Park Rapids Additions and Renovations  
PARK RAPIDS PUBLIC SCHOOLS

Project: S21144C - ISD #309 - Park Rapids High School Facility Improvements

**PR #1 - MNDOLI Required Plan Changes**

## Proposal Request #1 MNDOLI Required Plan Changes - Recommendation

**1A A204 FIRST FLOOR - AREA 4**  
SCALE: 1/8" = 1'-0"

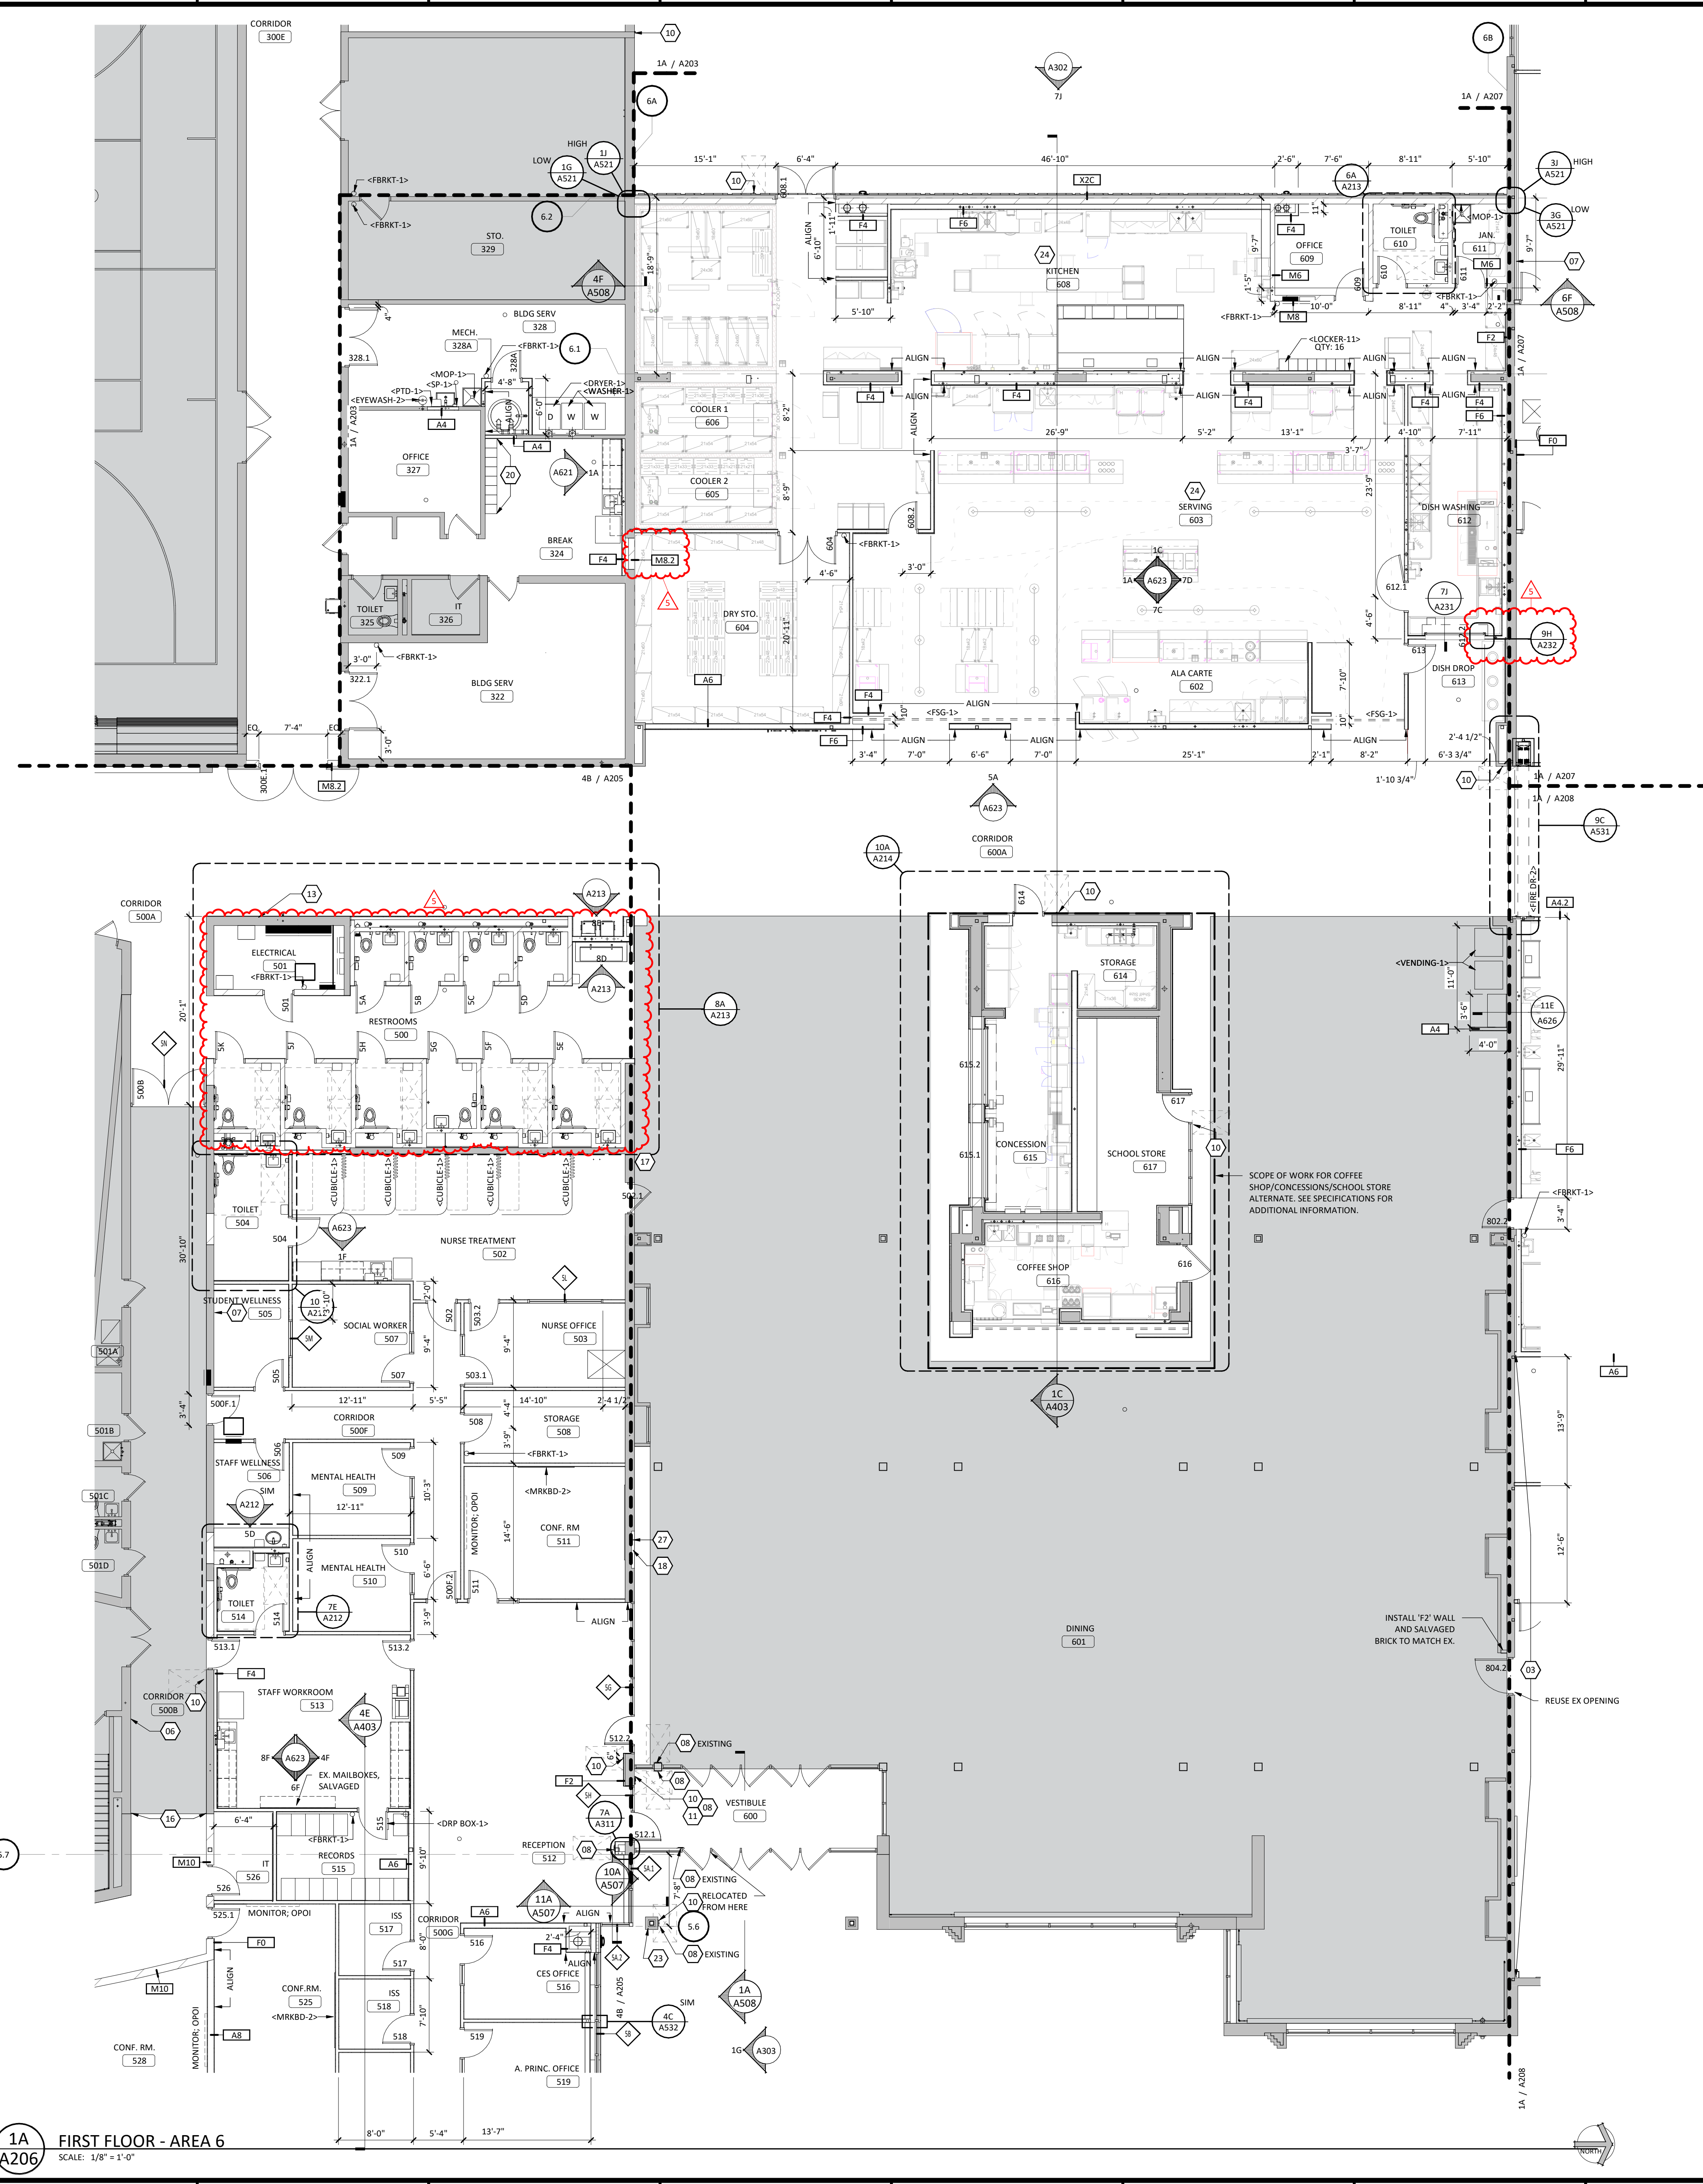
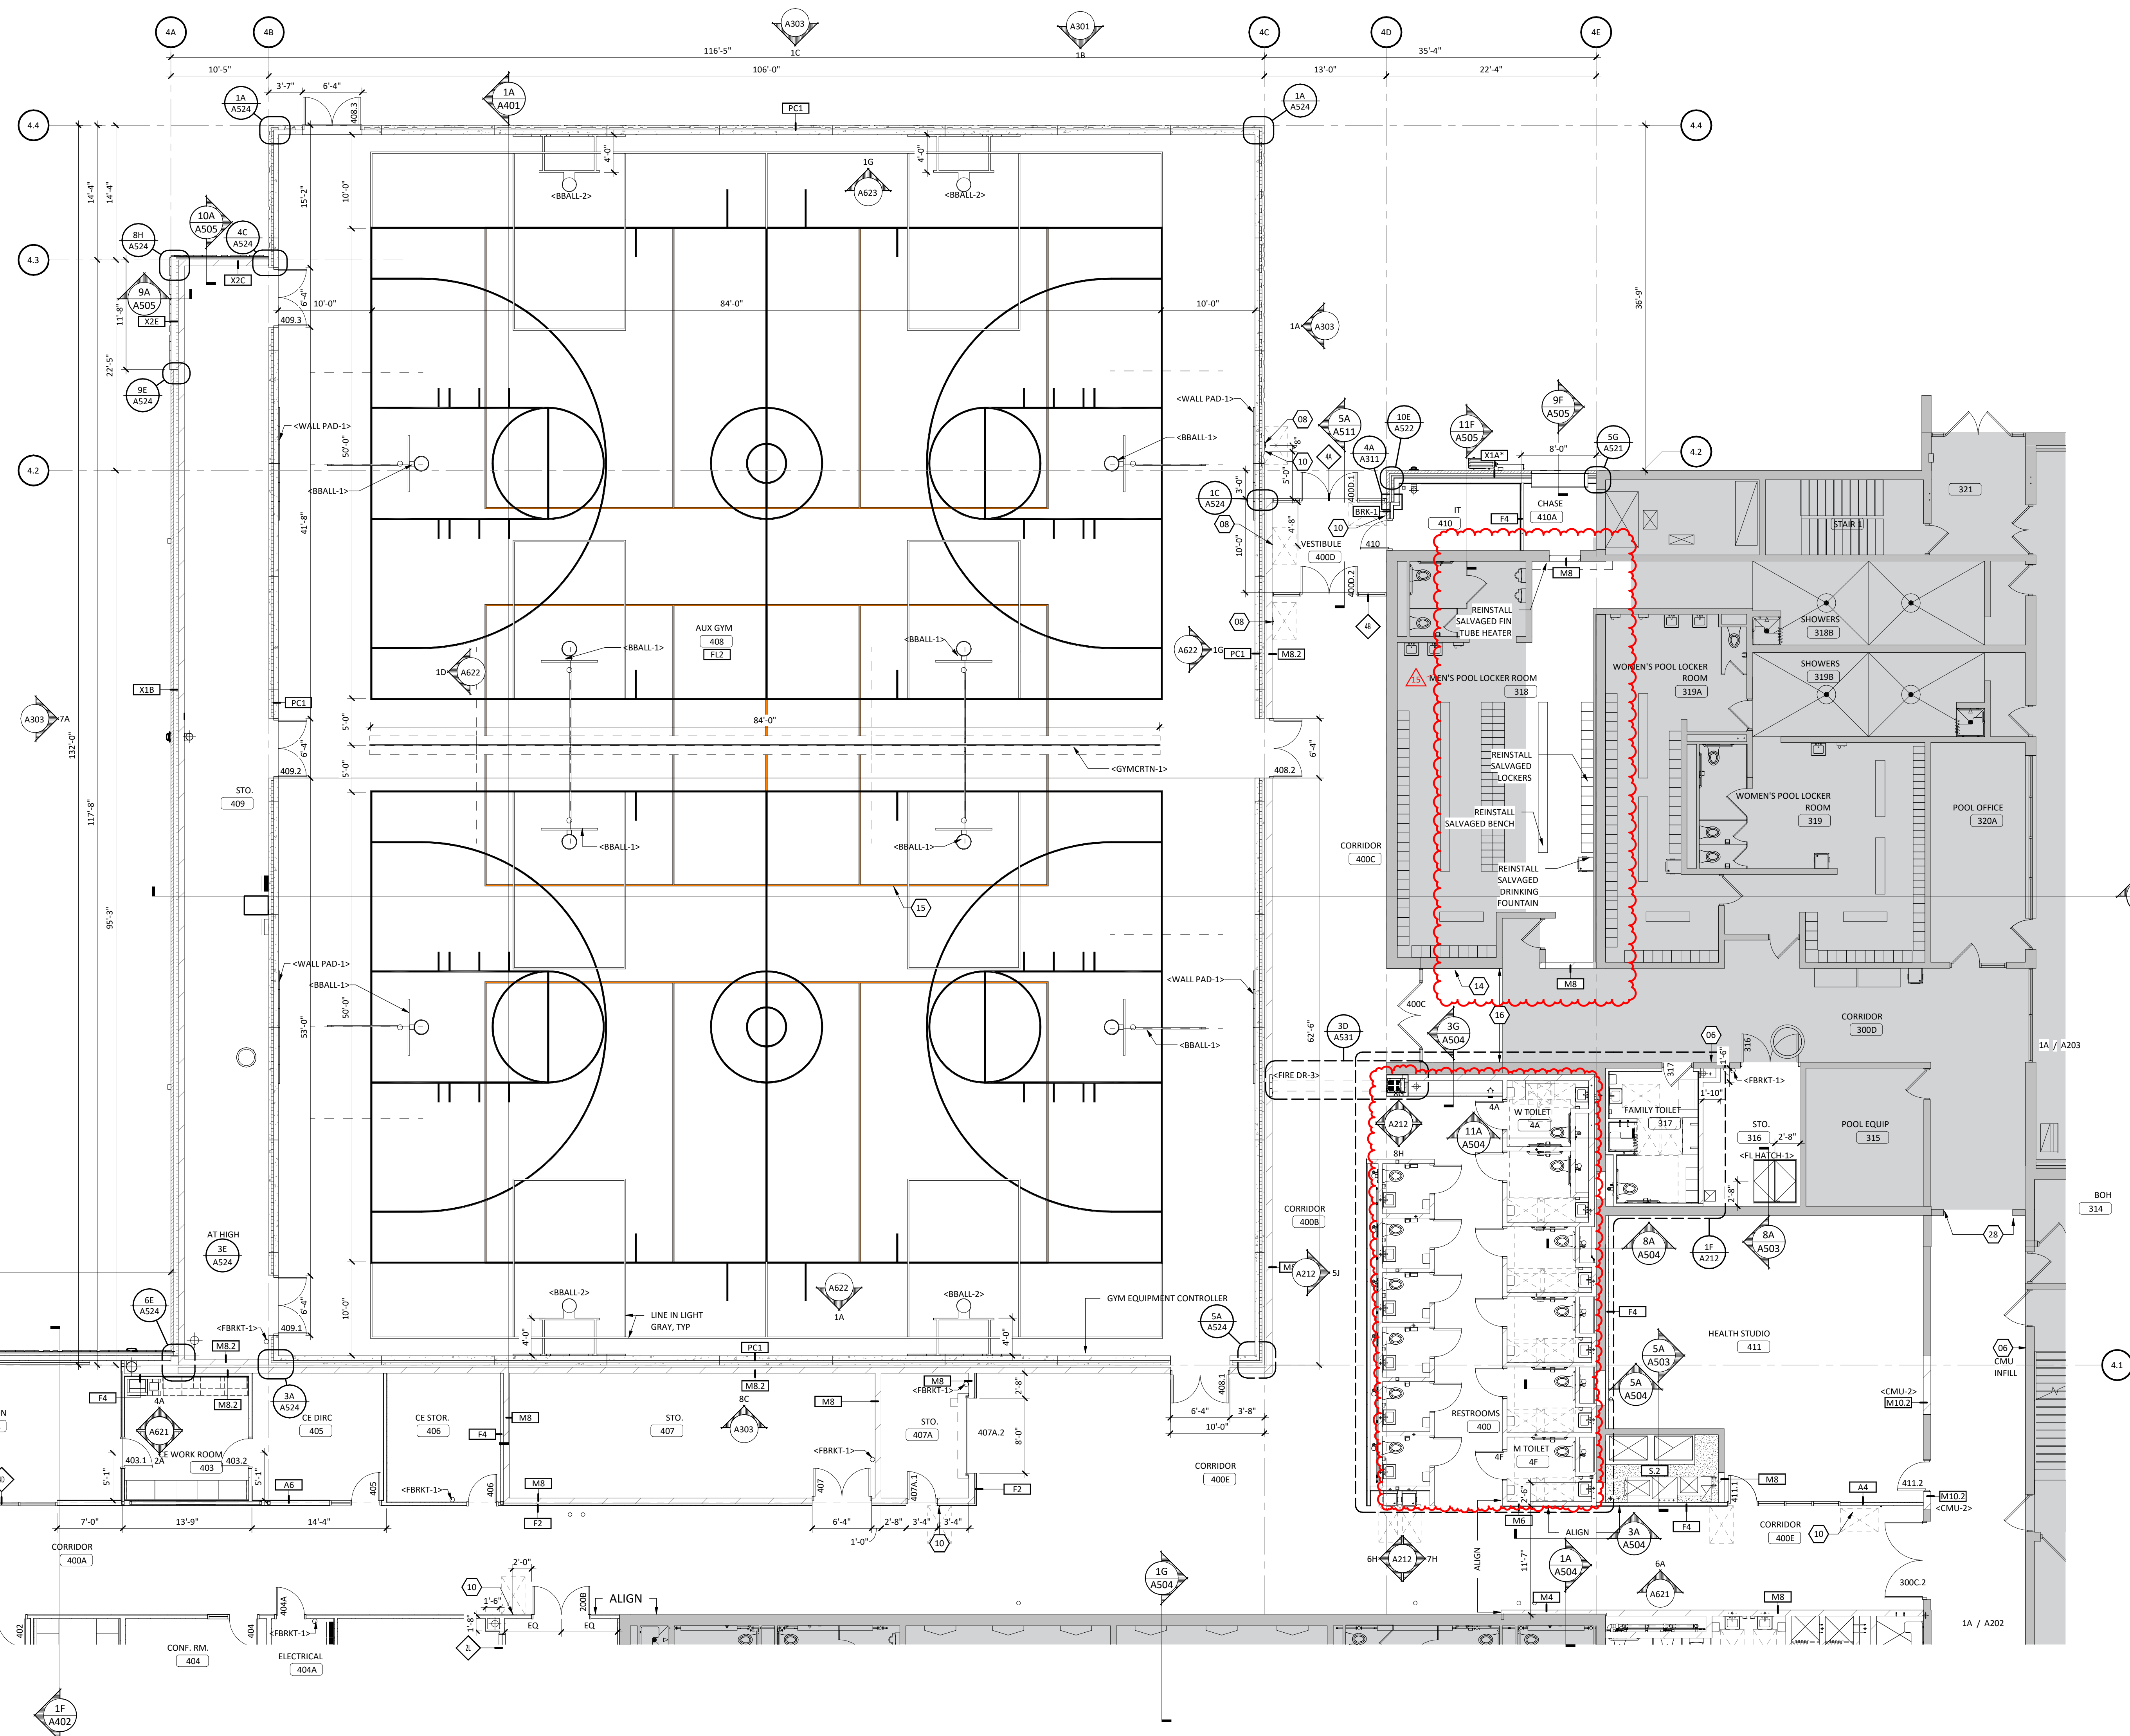
**Date Created:** 3/16/2023      **Created By:** Justin Maaninga  
**Status:** Open      **Scope:** TBD  
**Type:** TBD      **Change Reason:** Design Development  
**Description:** PR #1 - State Plan Review Changes
